IN THE DRAWINGS

REMARKS

V. REJECTION UNDER 35 U.S.C. §102(e)

FIG. 4

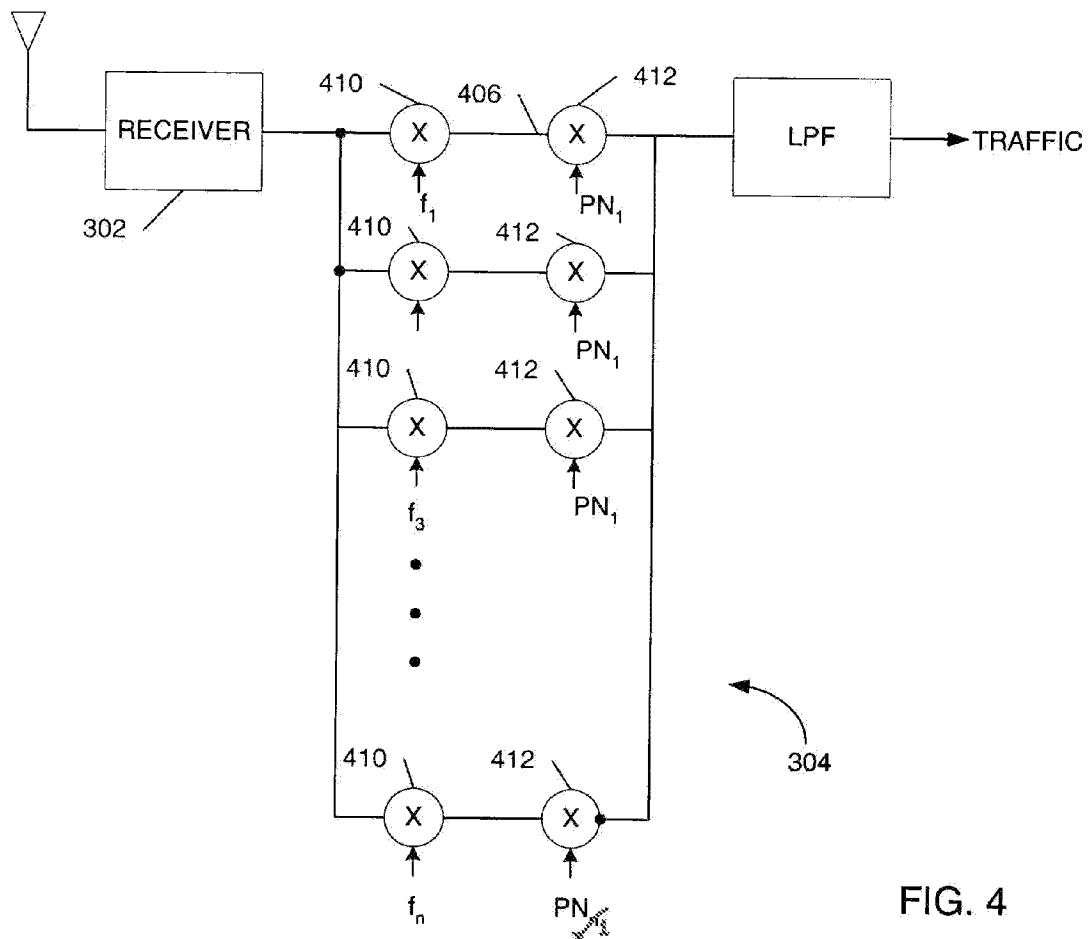
The attached sheets include changes to Fig. 4. The sheets, which include only Fig. 4, replace the original sheet including only Fig. 4. In as-filed Fig. 4, an element 412 is shown to accept a signal labeled " PN_n ", which is presently corrected to show " PN_1 " thereby corresponding to the description at paragraph [0043] of the as-filed application.

The attached sheets include changes to Fig. 4. The sheets, which include only Fig. 4, replace the original sheet including only Fig. 4. In as-filed Fig. 4, an element 412 is shown to accept a signal labeled "PN_n", which is presently corrected to show "PN₁" thereby corresponding to the description at paragraph [0043] of the as-filed application.
